Capital Facilities Planning

Addendum 3 – Questions and Answers

To: All Bidders
From: Sayim Malik
Project Manager, Capital Facilities Planning
Re: Project SU-022723 - Phase 3 Bathroom Rehab Project
DATE: JUNE 26, 2023

Date	06-15-2023
Project No.	1944
Drawing By	LJ
CHK By	SM
Scale	AS NOTED
	DOB Rev
E-102.00

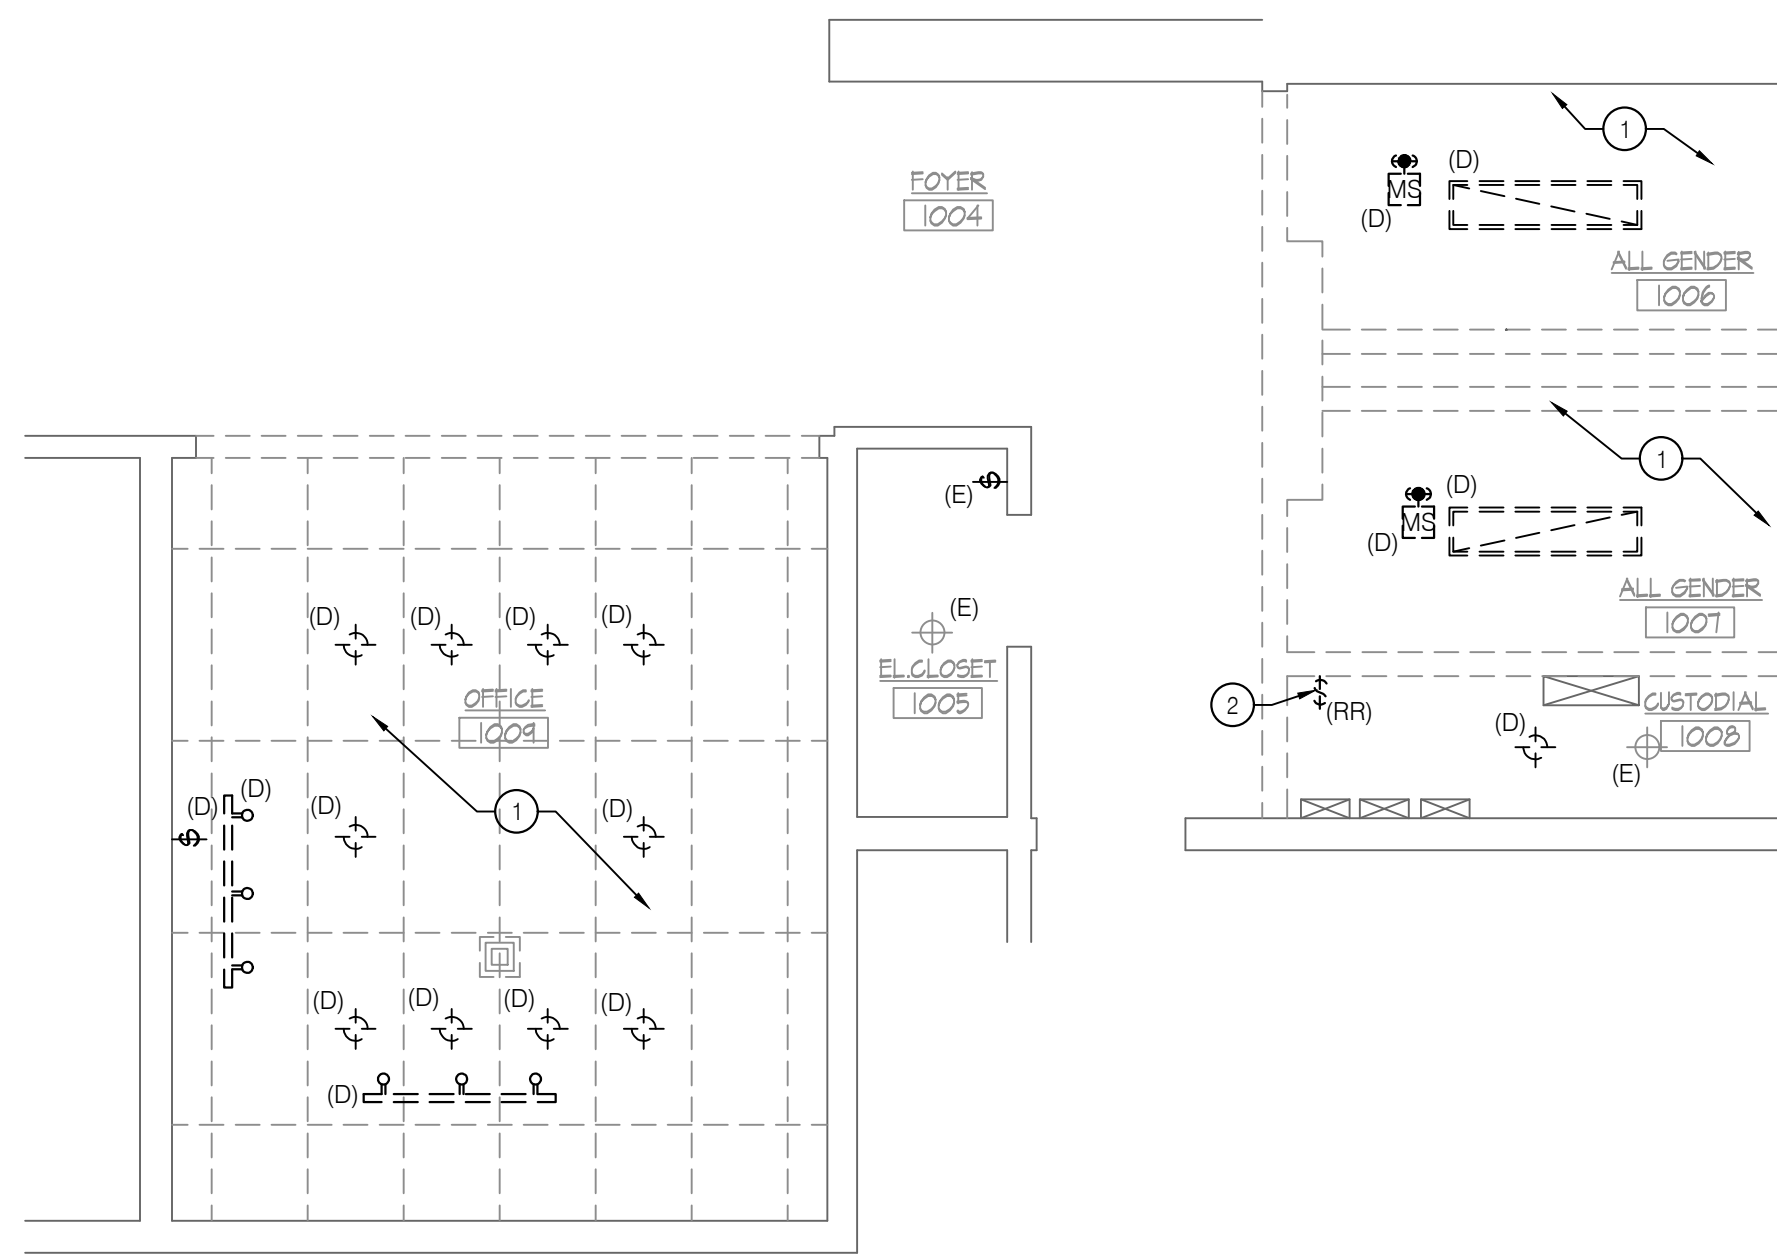
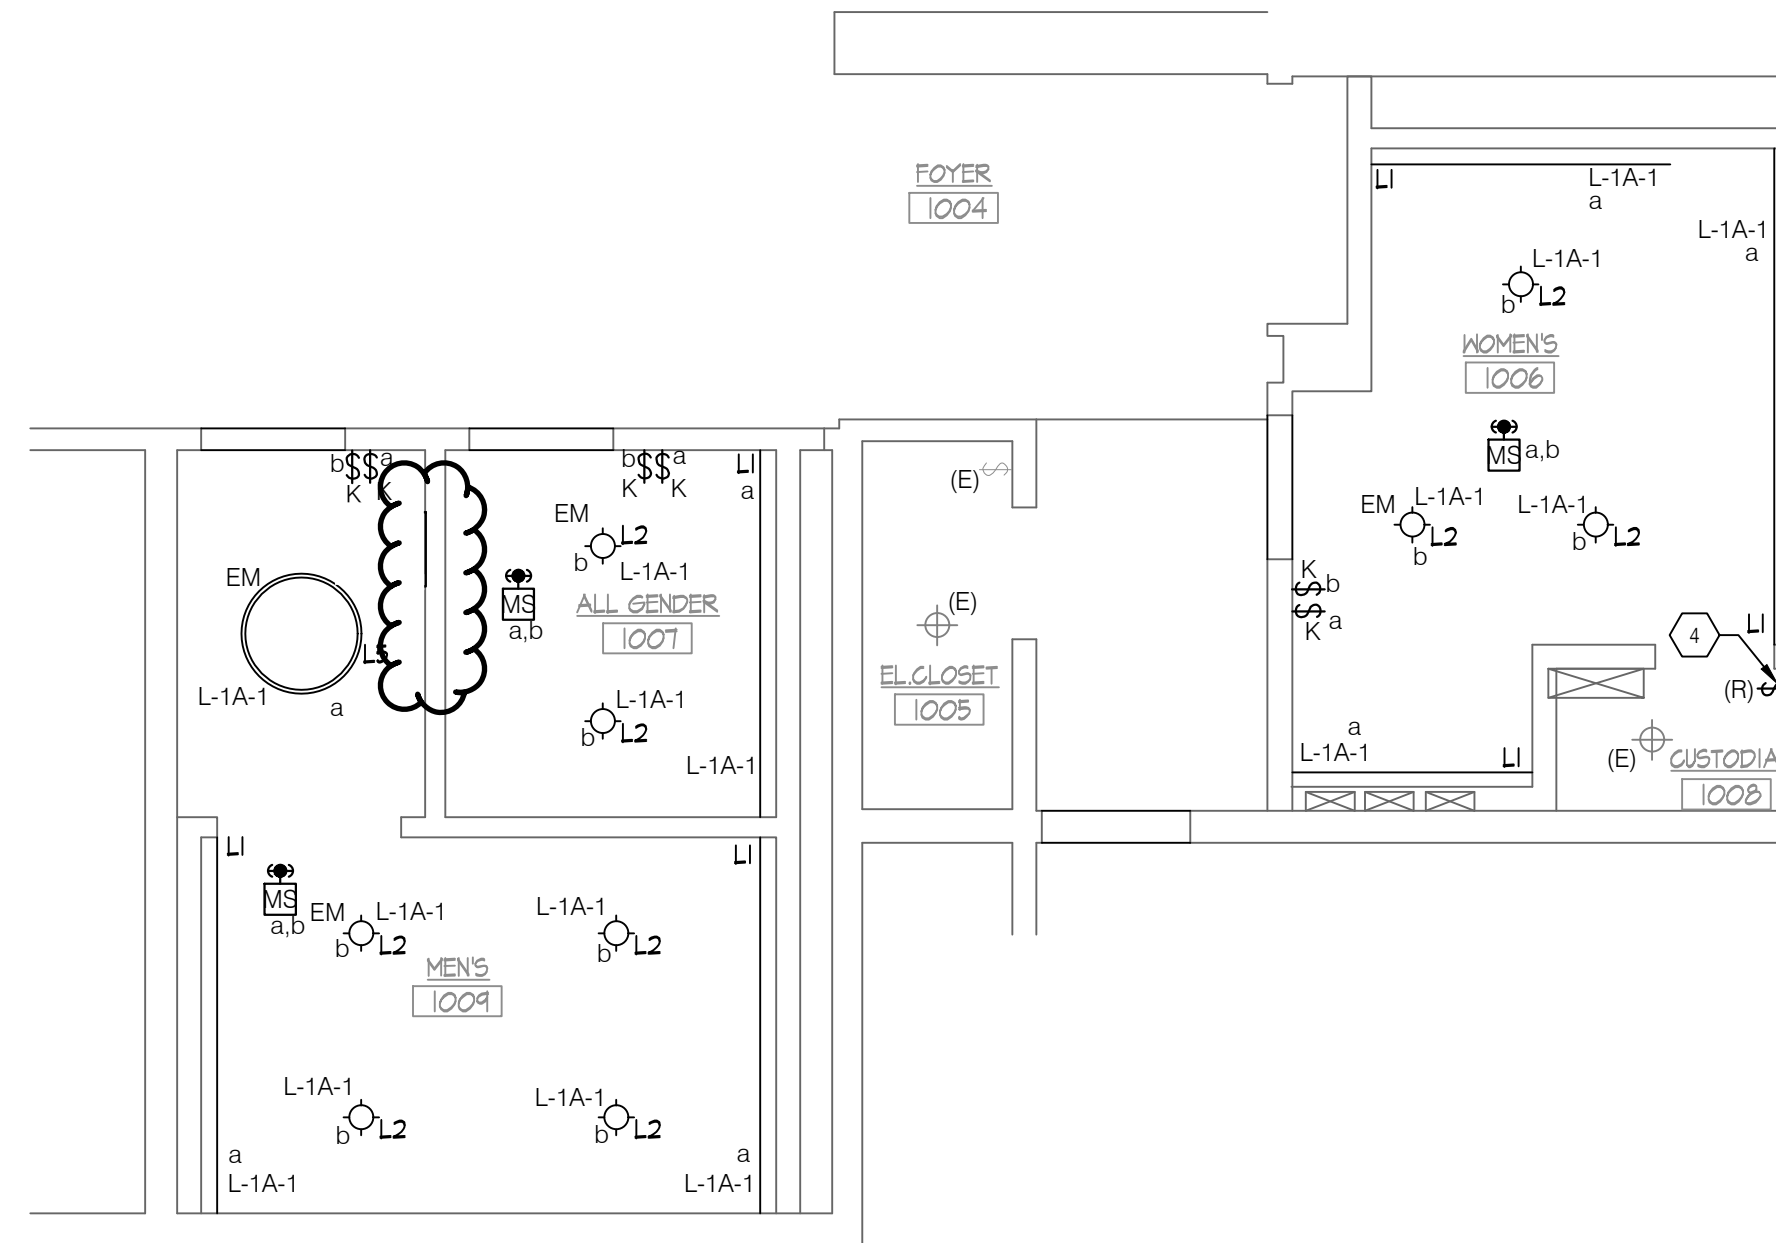
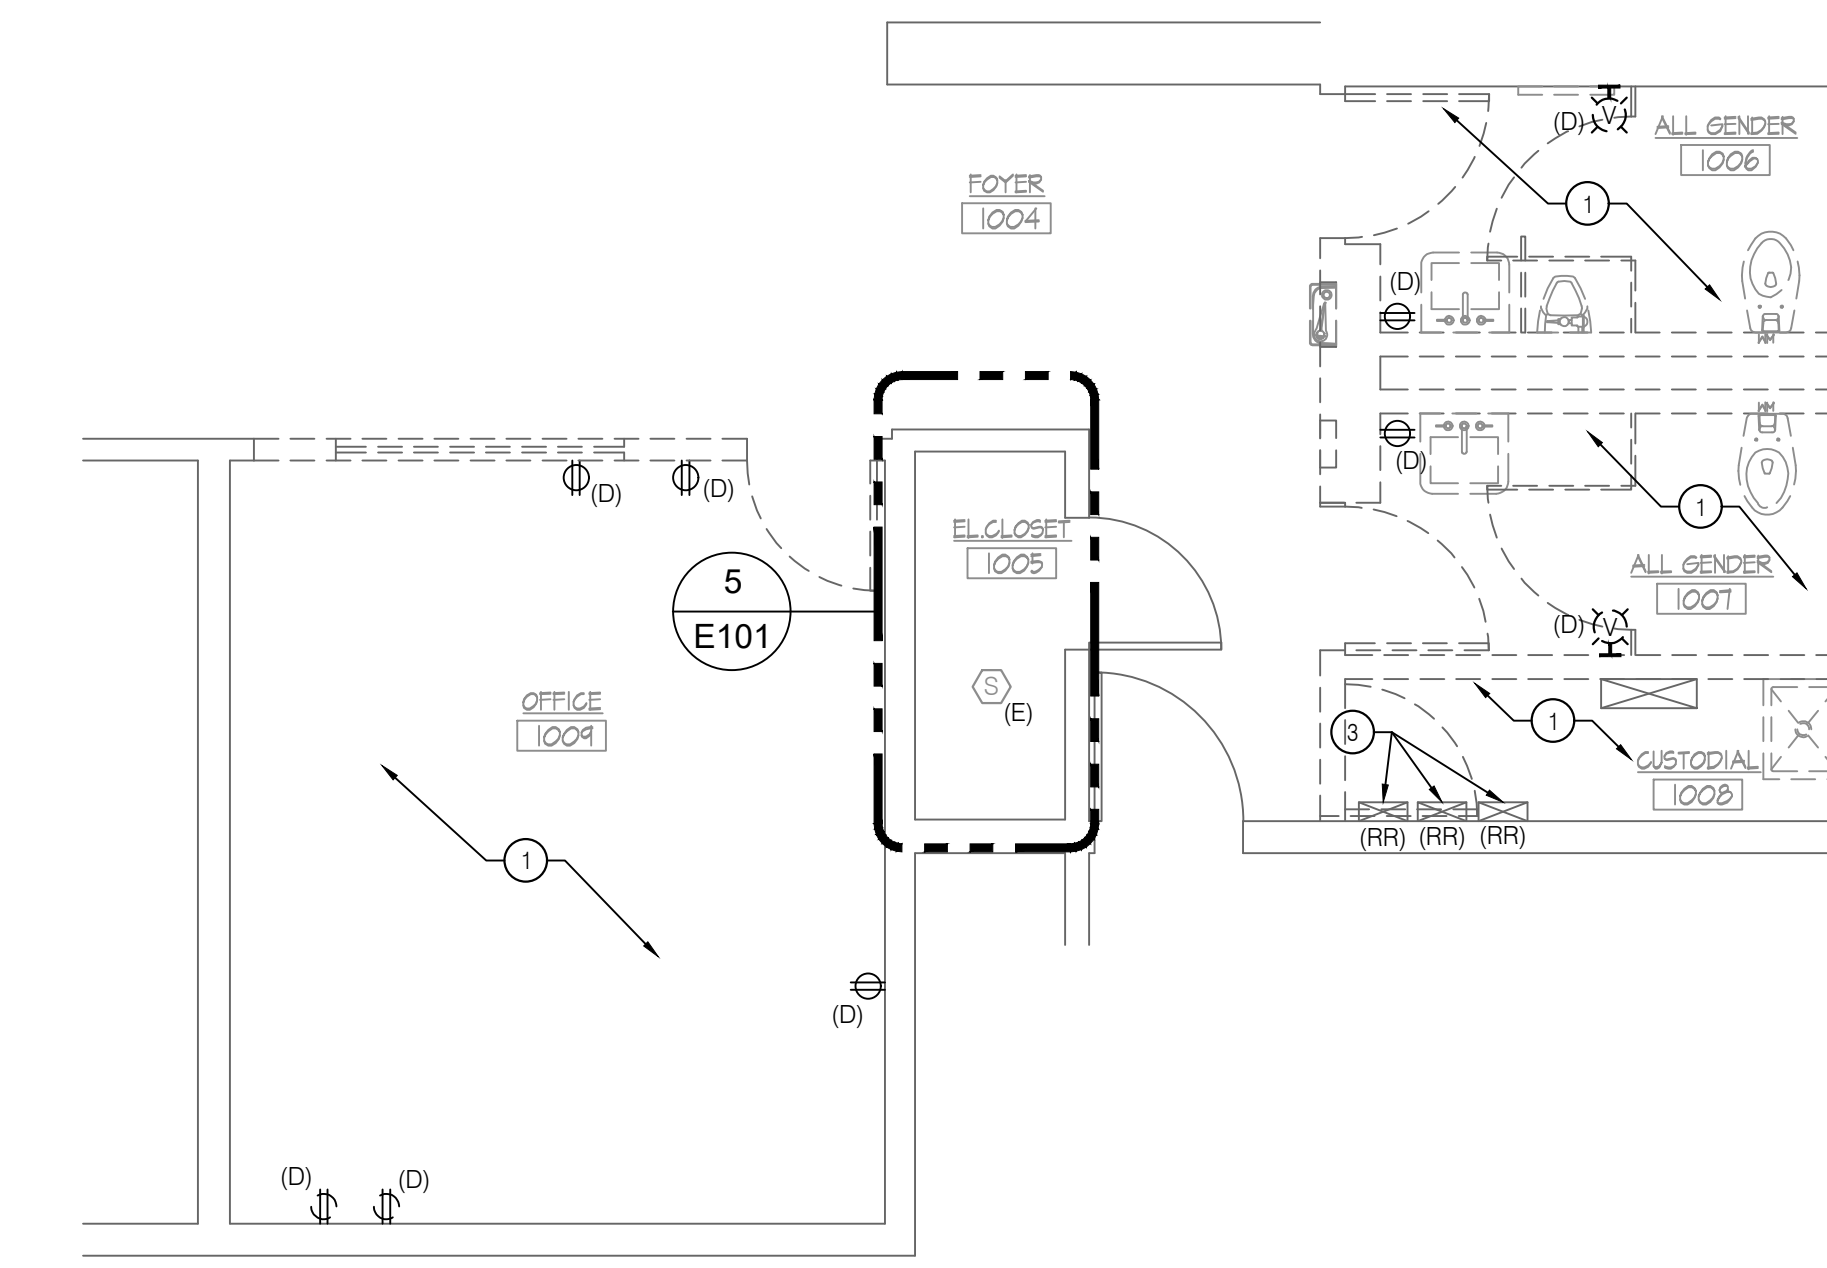
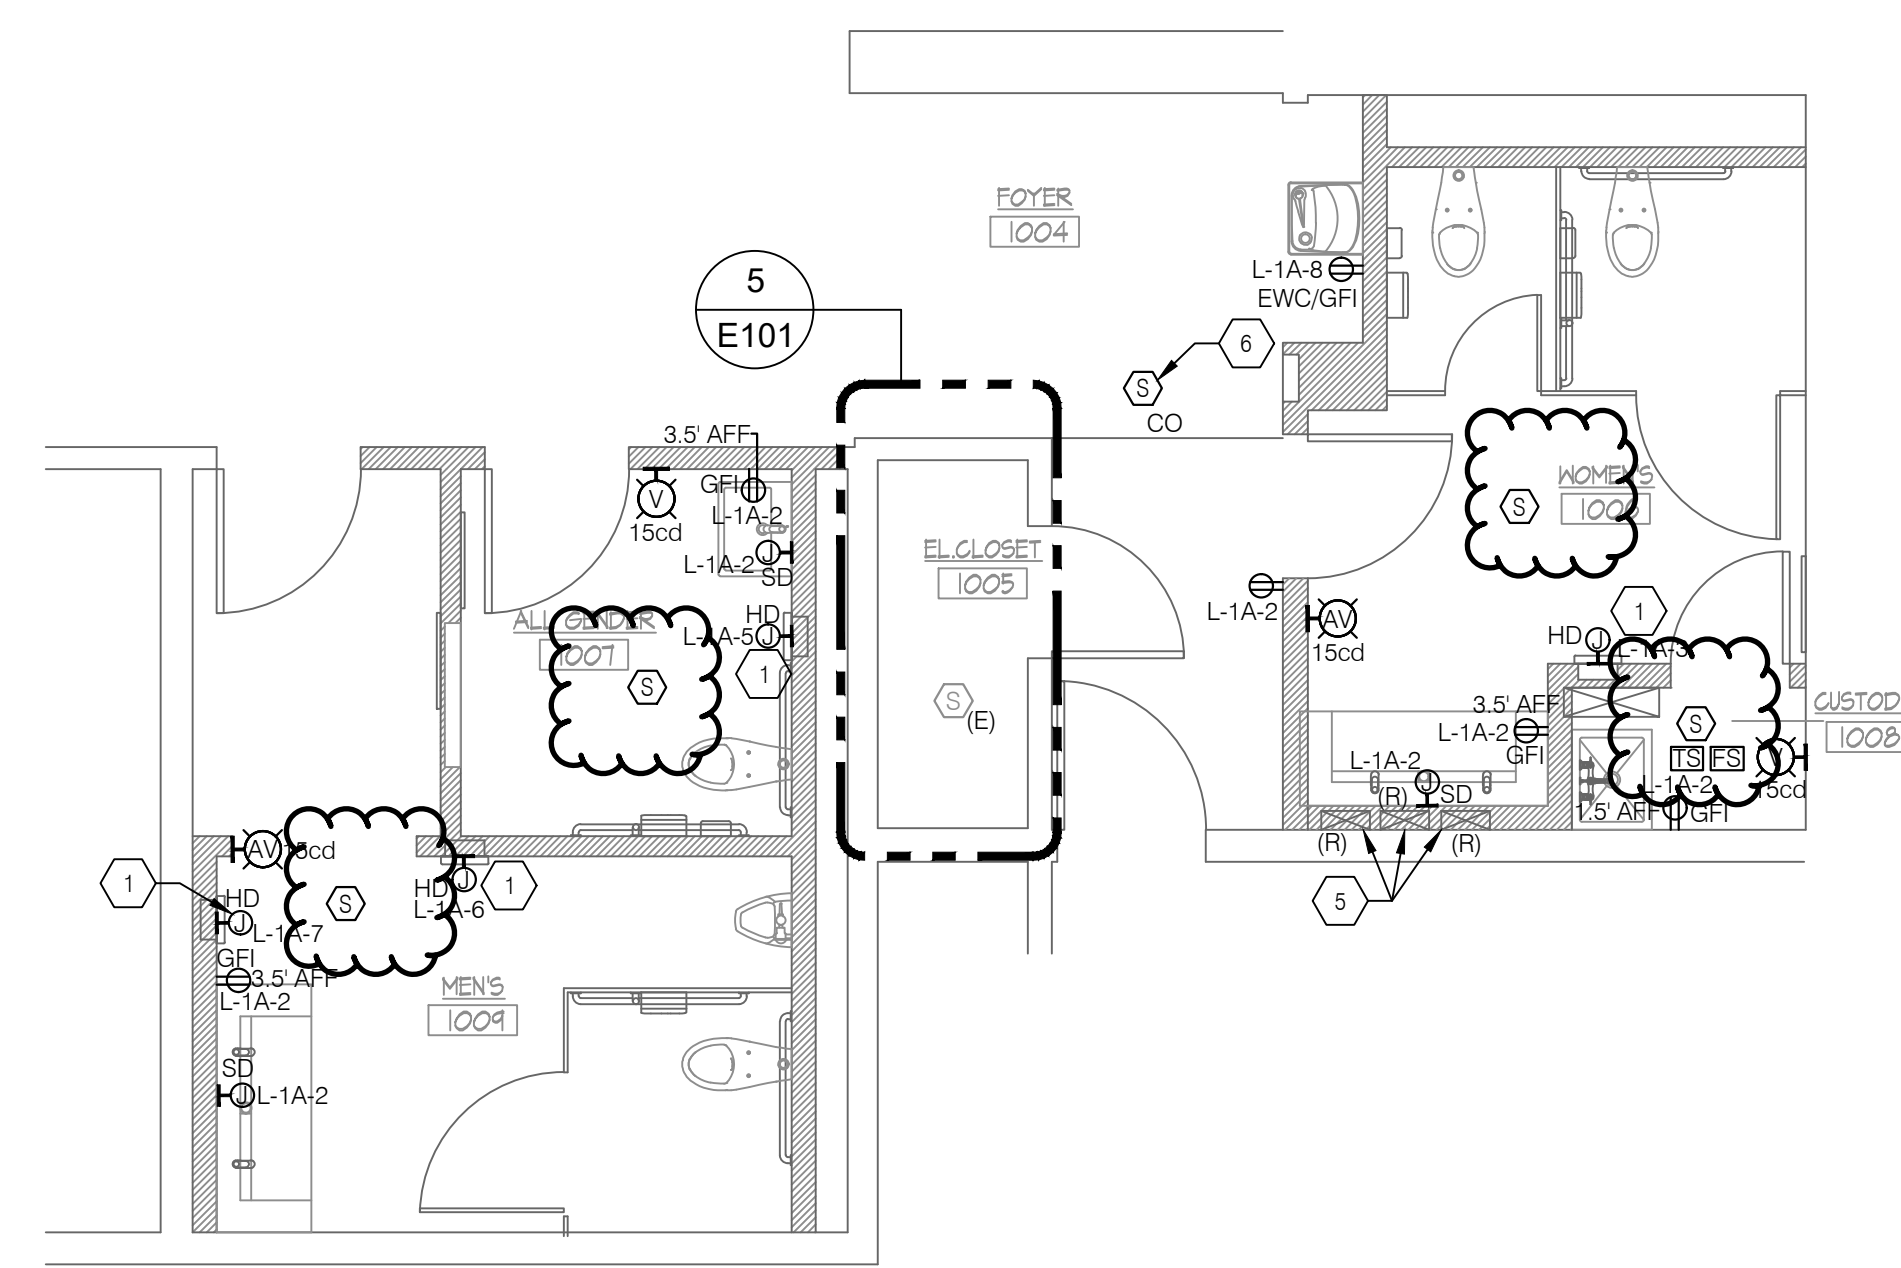
- Question 7: Campus Center North provide a Key Plan to Scale showing the Area of Work and the Electric Closet.
- Answer 7: *Key plan is indicated in the title-block on this sheet. Electrical room has been called out for reference. Refer to E-102.*

- Answer 10: *Please note this fixture has been specified with EM battery backup option.*
- Question 11: Drawing E-102.00 Detail #3 First Floor Lighting Plan Sheet Key Note #2 calls for one (1) 50-watt Inverter yet the Type L5 light fixture is 75 watts each. Are additional Inverters required and what power requirement?

- Answer 11: *Please note that all EM fixtures are battery backups.*
- Question 12: Drawing E-103.00 Sheet Key Note #2-provide a Key Plan to Scale identifying the location of the nearest Emergency Panel.
